Basic Concept for Smart Meter Specification based on RFC

July 12, 2012

Tokyo Electric Power Company, Incorporated

II. Major Revisions from Previous Specification

-1 . Adoption of International Standards (2) -IP-based network-

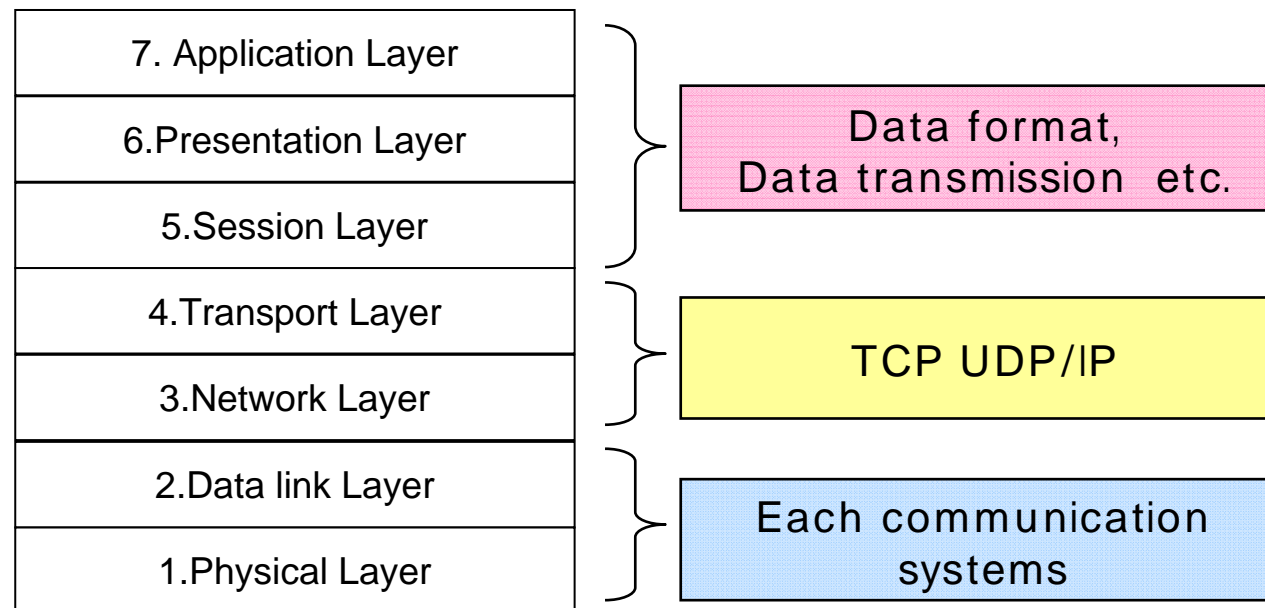
■ AMI network (route A) will be IP-based network in principle.

- Adopting IP will enable to separate communication systems (wireless communications etc.) and data transmission (e.g. Standards for meter data structure defined in IEC or ANSI etc.), which make flexible system for future change or expanding function.

-1 . Adoption of International Standards (3) -Data format-

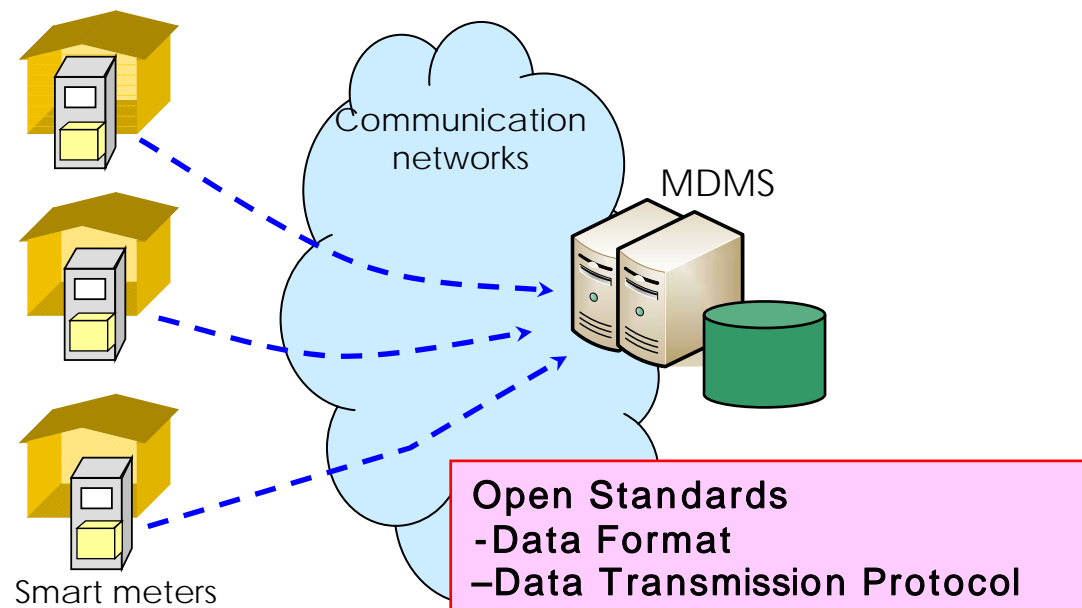
■ TEPCO will aim to deploy international standards for metering data format and transmission protocols.

- International standards will be basically adopted for metering data and transmission protocols considering and comparing development cost and security. However, if TEPCO's conventional specification is admitted to have advantages, TEPCO's specification will be open and become available to enter various vendors.

-3 . Functions of Smart Meter (1) -Adoption of integrated structure-

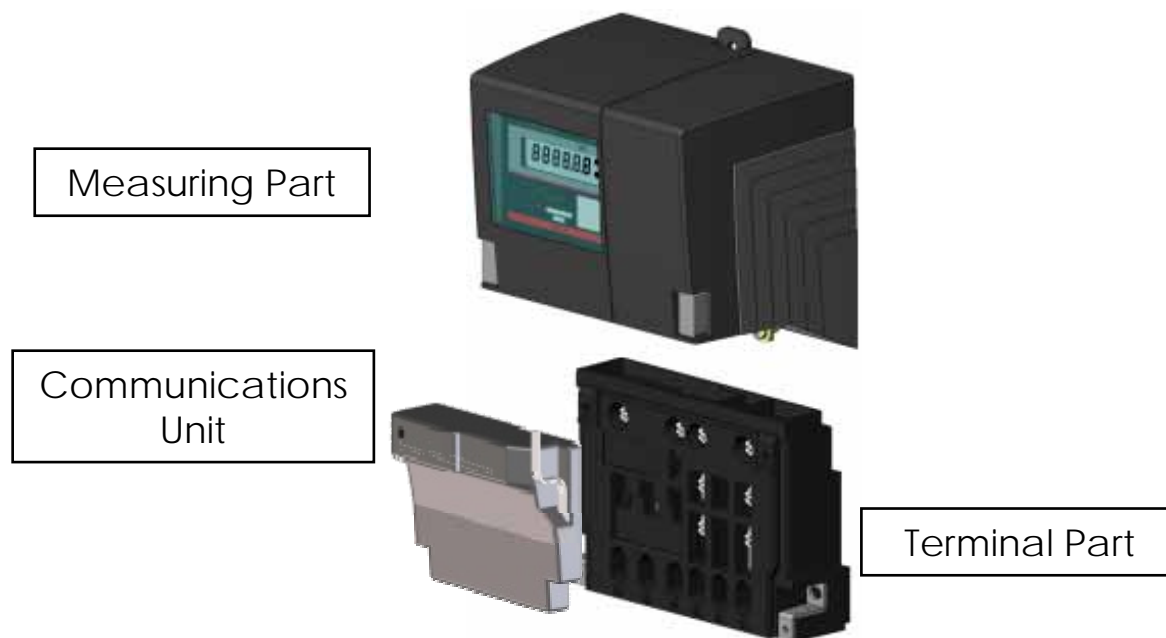
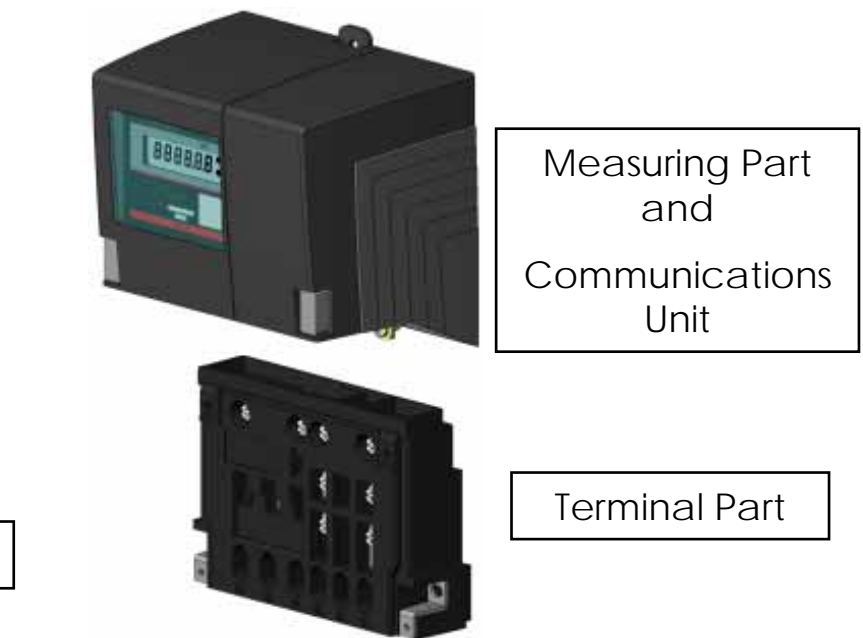
- As for the structure of the measuring part and the communication part of the smart meter, we will adopt integrated structure as well as separated structure, considering possibilities to reduce cost by decreasing the number of parts.

-3 . Functions of Smart Meter (3) -30-minute meter reading-

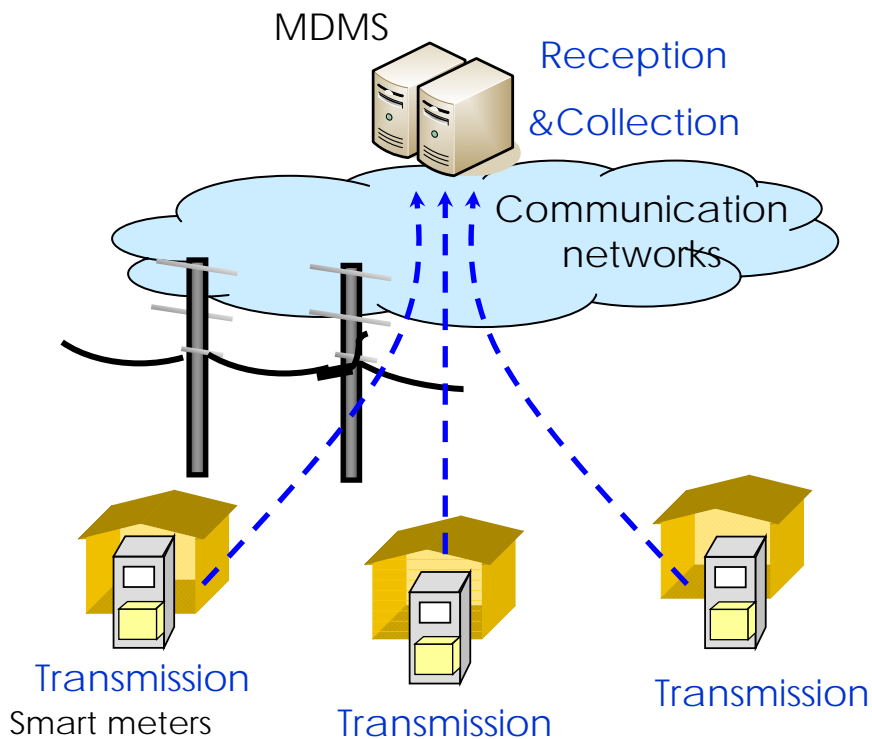
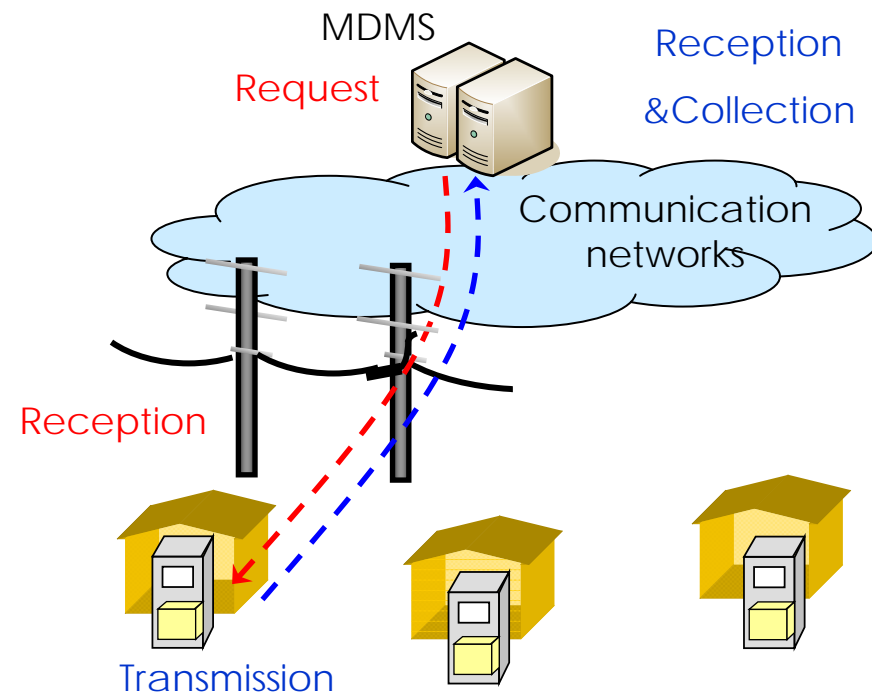
- Smart meters transmit 30-minute meter reading to the MDMS according to designated interval. Transmission interval shall basically be 30 minutes, and can be changed with the expandable function.
- In case of loss of meter reading occurs, meters retransmit the data according to the request from MDMS such as acknowledgement of connection recovery and re-reading order.

-3 . Functions of Smart Meter (4) - Demand Response -

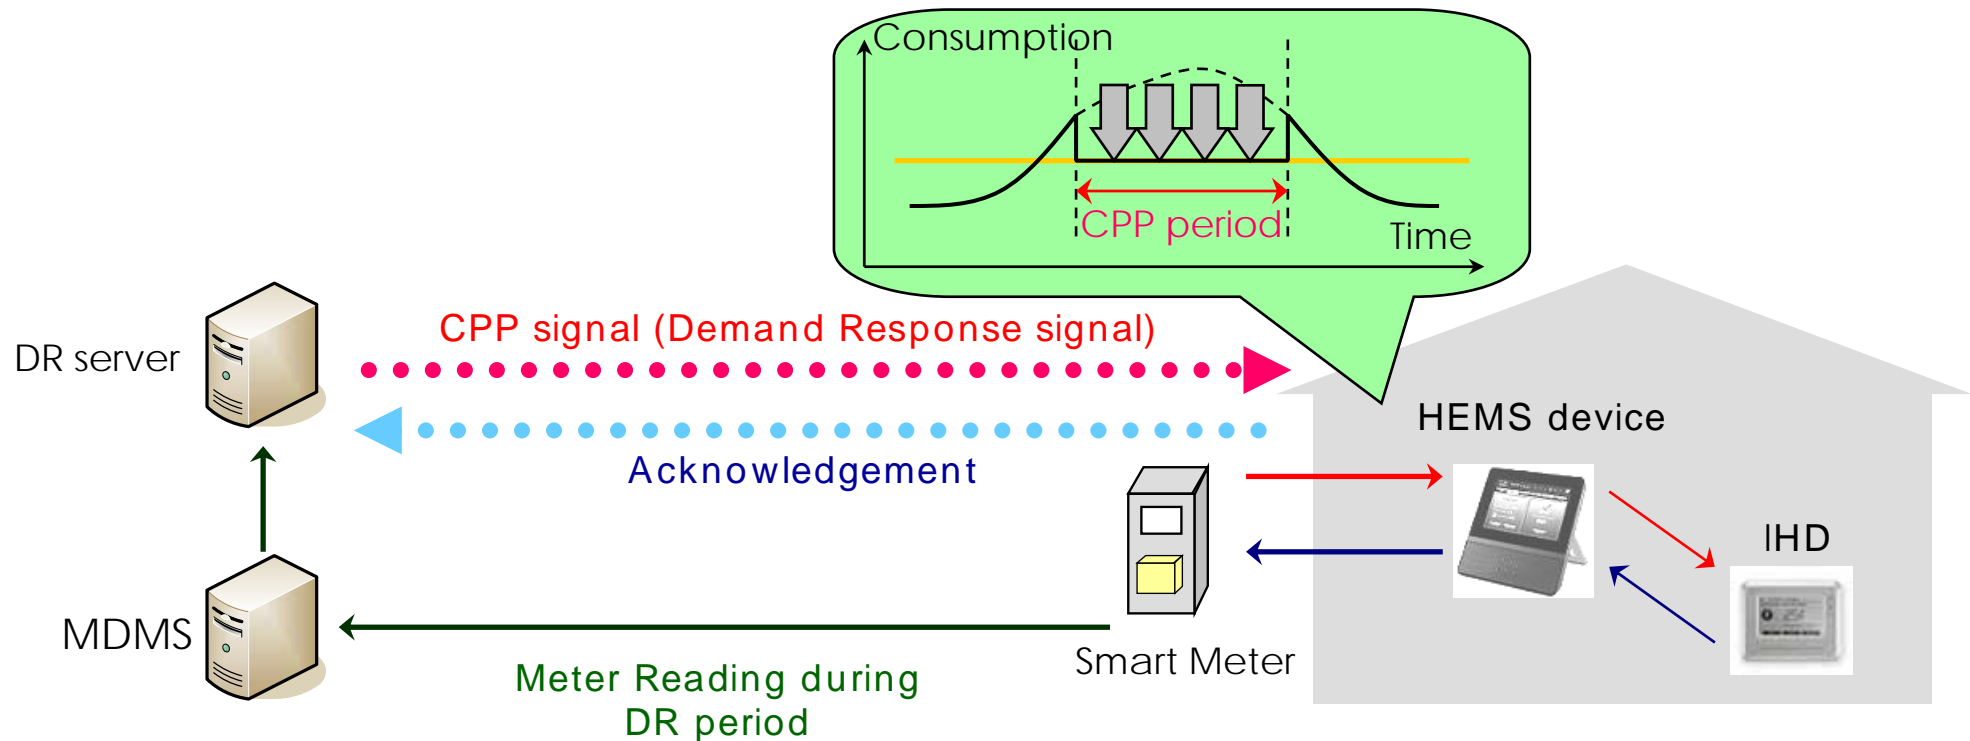
- Smart meters transmit and handle DR signals according to DR services such as CPP (Critical Peak Pricing) , PTR (Peak Time Rebate) and so on.
- For newly designated DR services, the interface which can install additional functions will be equipped sufficiently.

-3 . Functions of Smart Meter (5) - Future Services -

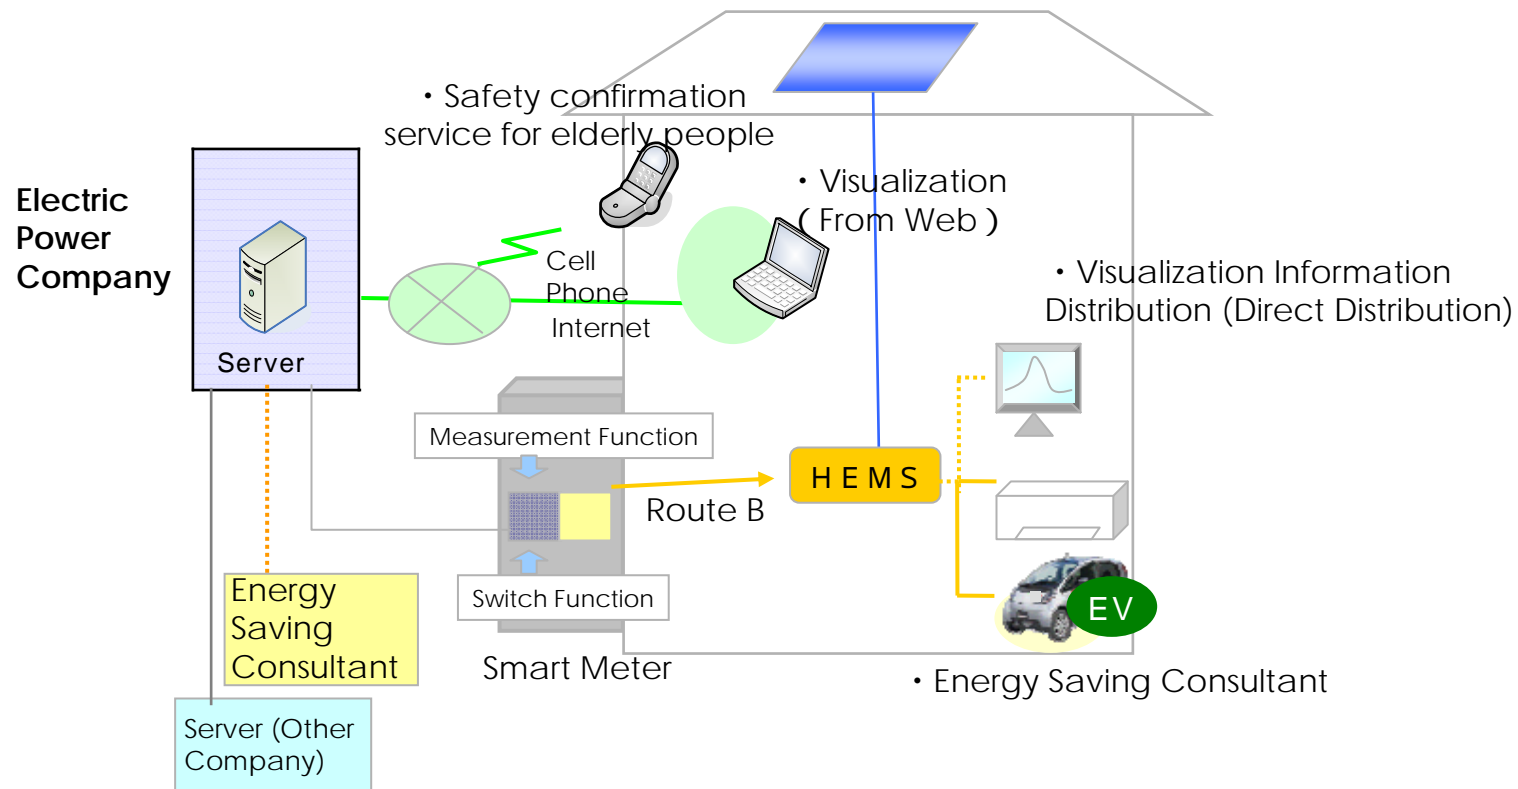
- We assume co-metering with gas and water company, visualization service of electric consumption, nega-watt aggregation business, safety confirmation service for elderly people and energy conservation/energy saving advice as specific services.
- Interface in the smart meter which can additionally implement the desirable functions for future services will be equipped sufficiently. In this case, system architecture must secure fairness for new comers such as new energy business supplier's in the wake of future full electricity deregulation.

-3 . Functions of Smart Meter (6) - meter setting & control -

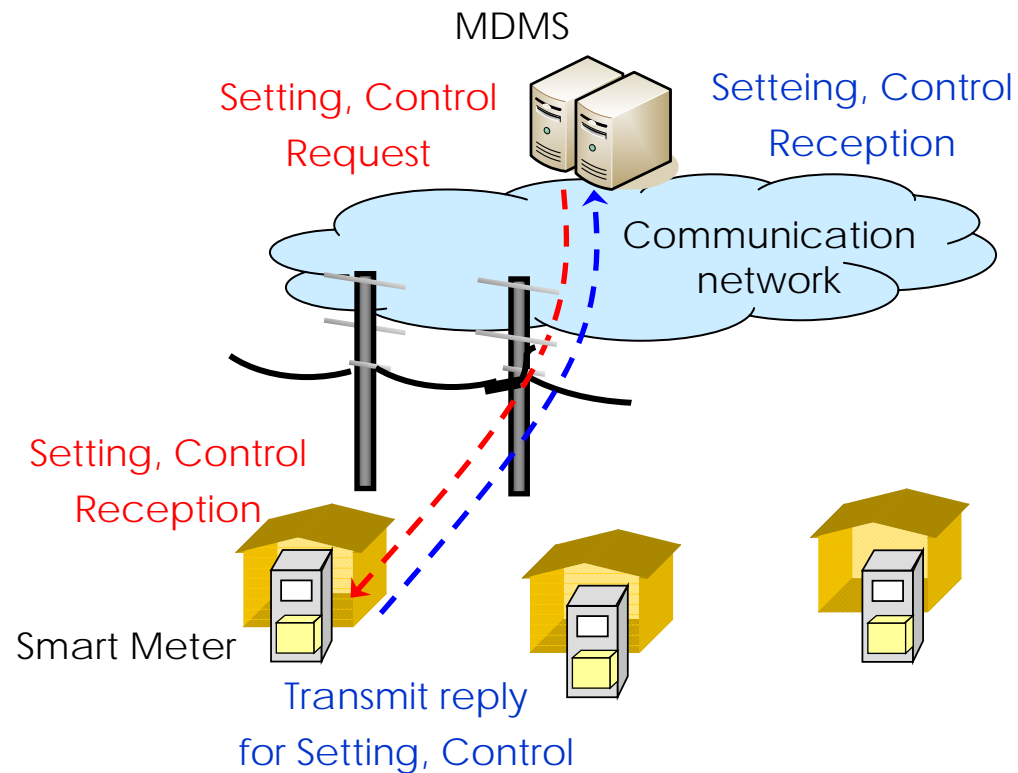
- The smart meter that received the setting and control request data for switch control and others from MDMS executes the requested process, and transmits the results to MDMS.

-3 . Functions of Smart Meter (7) - Hand-held terminal communication -

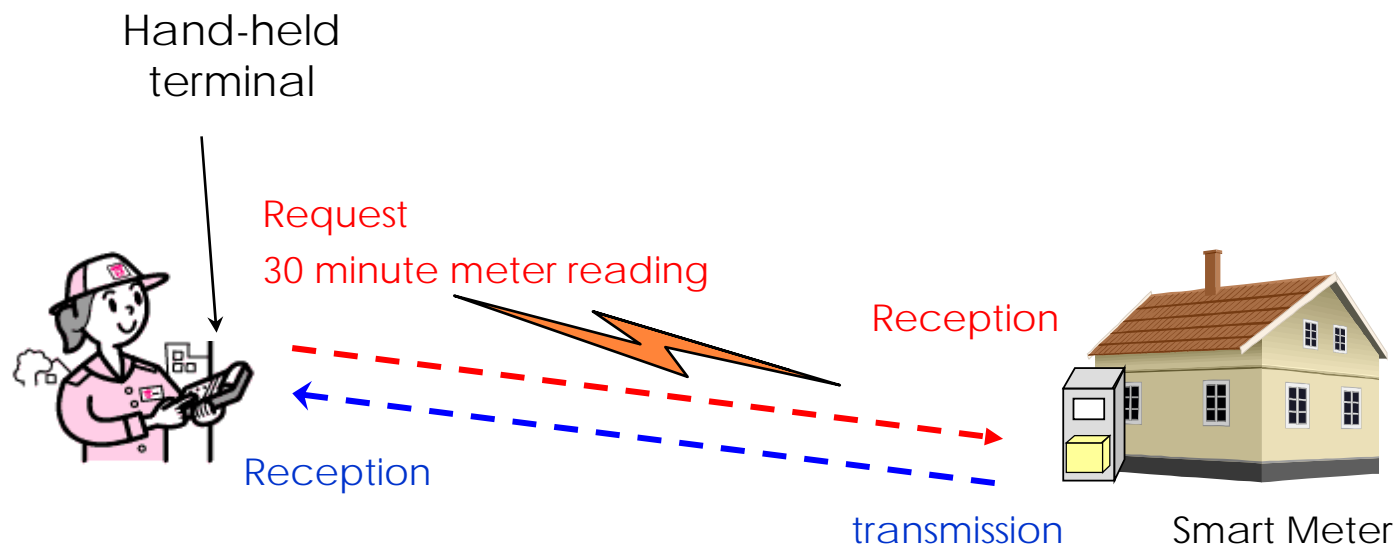
- When communication via the communication network between MDMS and smart meter is not available, meter reading, setting and control can be performed directly by using hand-held terminal on site.

-3 . Functions of Smart Meter (9) – Operation and Maintenance -

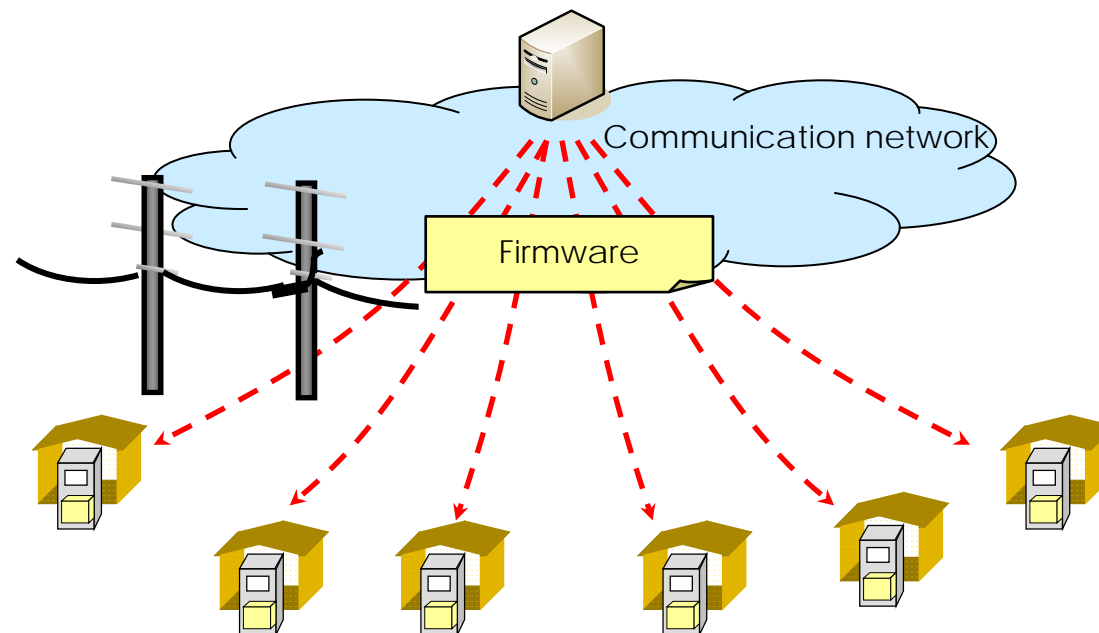
- To manage the large-scale network efficiently and accurately, smart meter automatically transmits facility management information to MDMS.
- To effectively improve the smart meter, function enhancement for future service and the countermeasure of security depression, the **firmware** is remotely updated using communication network.
